CITY OF RAYMORE

ADDENDUM NO. 1

West Hawk Ridge Improvements
Project #22-386-201

Addendum No. 1 - BID DATE REVISED - Question and clarification.

UTILITY PLANS
 211082
 Sheet Number 10 of 18

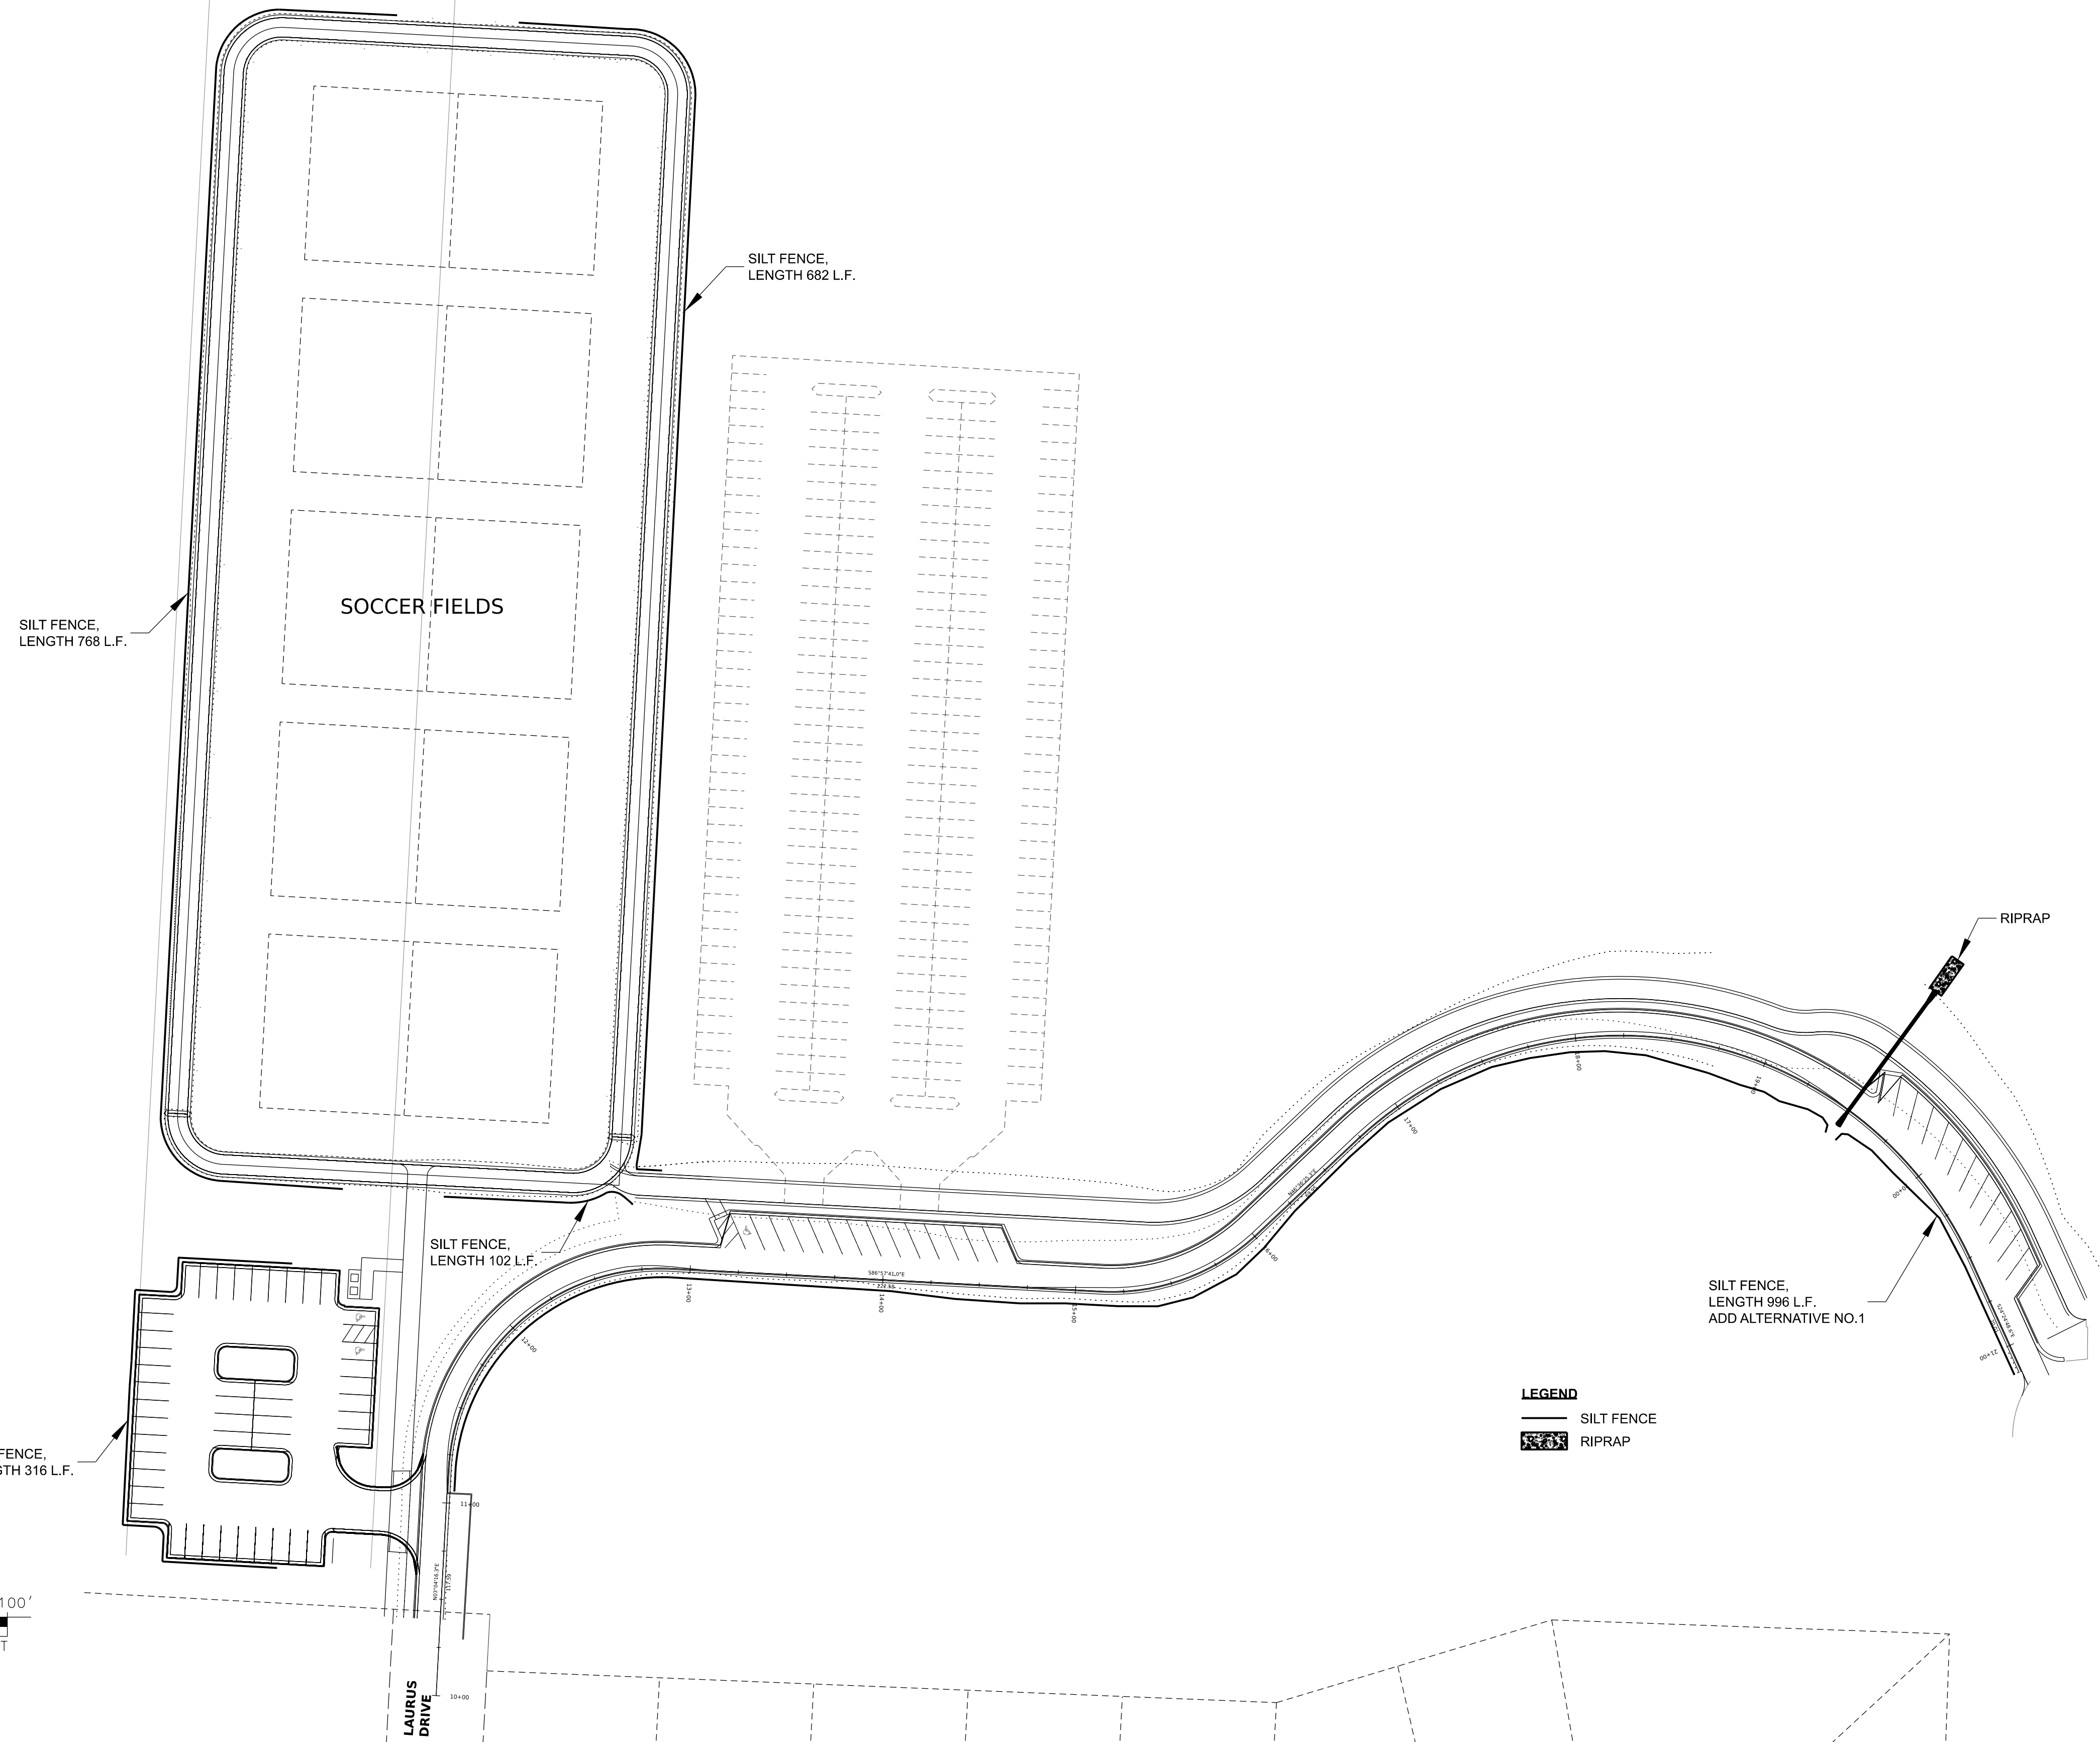
12. Question: What does the electrical line tie into?

13. Question: What does the waterline tie into?

Answer: The location has been labeled on the utilities plan sheet. Contractor is responsible for coordinating the actual connection point with Evergy.

Answer: The location has been labeled on the utilities plan sheet.
